**Head of Planning Services
Arun District Council**

Your Ref: *FP/246/21/PL*

3rd Party Representation - 26 Felpham Road, Felpham, West Sussex, PO22 7AZ

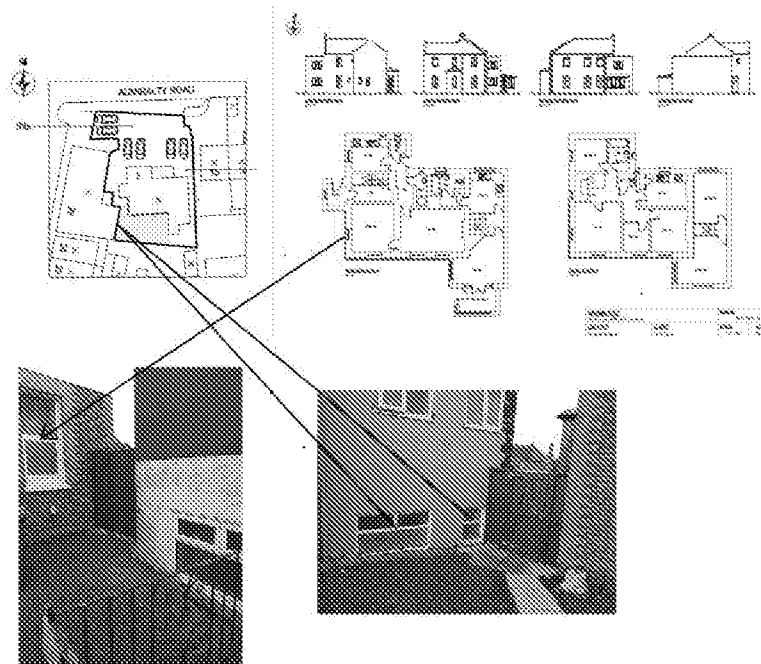
The existing application site is within a retail shop use and the section of the building at the rear of the property, which is closest to 2 Admiralty Road, is used for purposes incidental to the shop. The room at the rear is shown to be empty of any internal features on the survey plan ref SU-01.

The proposed ground floor plan shows the room at the rear of the building being used as the kitchen serving the café. Whilst no new openings are to be created in the north or east elevation of the proposed new kitchen, there are already two windows in place in the east elevation and one window in the northern elevation of this room.

The use of the room will be transformed from a benign retail shop floor area (lightly used during the daytime and only for retail / storage purposes) to a heavily used commercial kitchen serving a café (and prospectively other uses) that will be open from 08:00 to 16:00 on seven days a week (including Sundays and Bank Holidays), and additionally between 18:00 and 23:00 Mondays to Saturdays.

Immediately adjacent to this commercial kitchen and bordering onto the opening windows is the garden amenity area of 2 Admiralty Road. In addition to the outside amenity space for no.2 are bedroom windows at ground floor level less than 2-3m from the windows serving the commercial kitchen. The noise outbreak from the commercial kitchen, through the existing openings within the north and eastern walls of the building, up to 23:00 at night, is likely to cause significant noise and disturbance to the peaceful enjoyment of the residents of 2 Admiralty Road.

We would therefore request that the Local Planning Authority seek amendments before granting any planning permission to require that the windows serving the commercial kitchen to be blocked up or fitted with appropriate noise attenuating glazing that must be fixed shut at all times. In any other respect, it would be unreasonable to grant planning permission with windows opening onto a neighbour's garden and directly within 2-3m of bedroom windows.

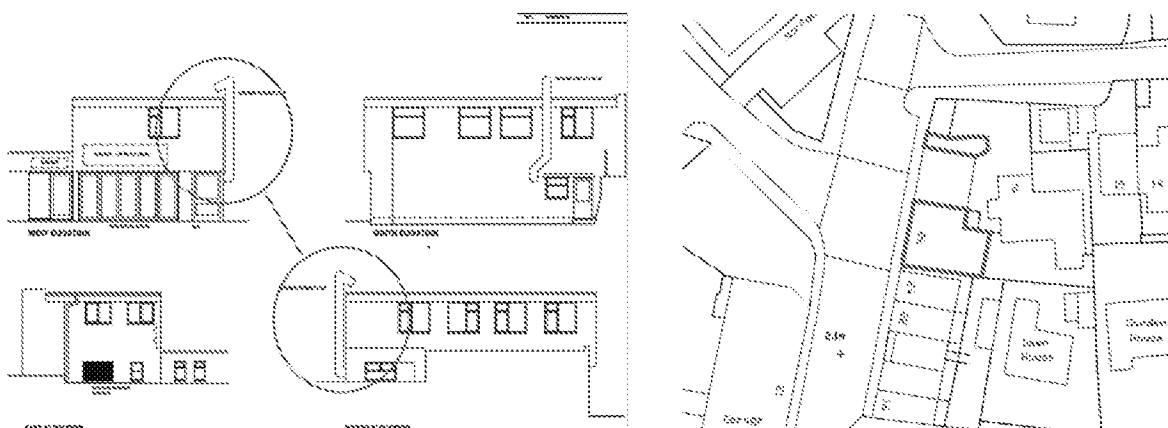
We would firstly point out that the flue is shown incorrectly on the proposed elevations. The flue is shown on the south side of the building on the west elevation, and the east side of the building on the north elevation. This leads to ambiguity in terms of the position of the flue. The ambiguity is also not resolved because the redline of the application site has excluded the flue (the redline is clearly shown running along both the south and east walls and not jutting out to include the flue notwithstanding the fact that the flue projects approximately 500mm from the wall).

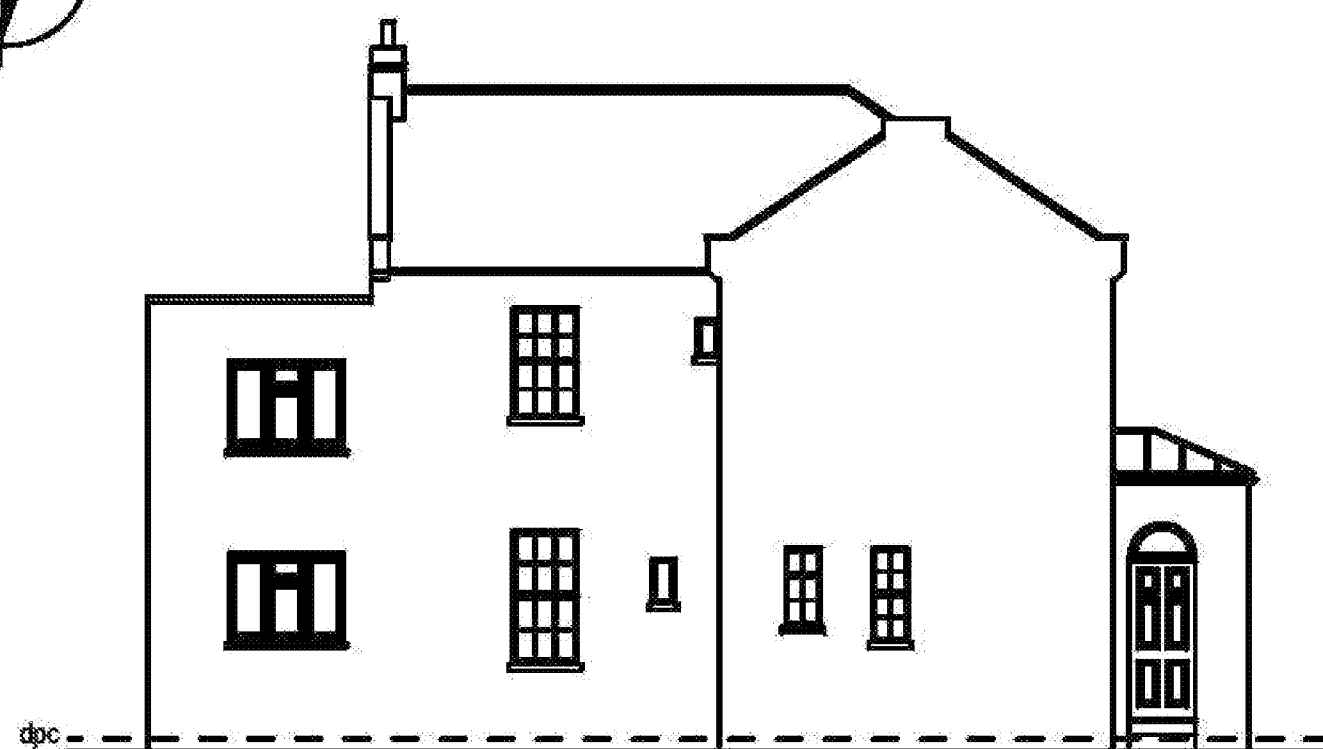
Secondly, even were the flue to be located on the southern elevation of the building (with just the north elevation being incorrect), our client has tenants that live within 2 Admiralty Road which have respiratory conditions that would make them very sensitive to any air pollution. This is particularly the case as the flue would be positioned south-west of the residential receptors and affected by the prevailing wind. We would therefore expect that the Environmental Health Dept be consulted on the application and that they stringently assess the quality of the specification of equipment being used.
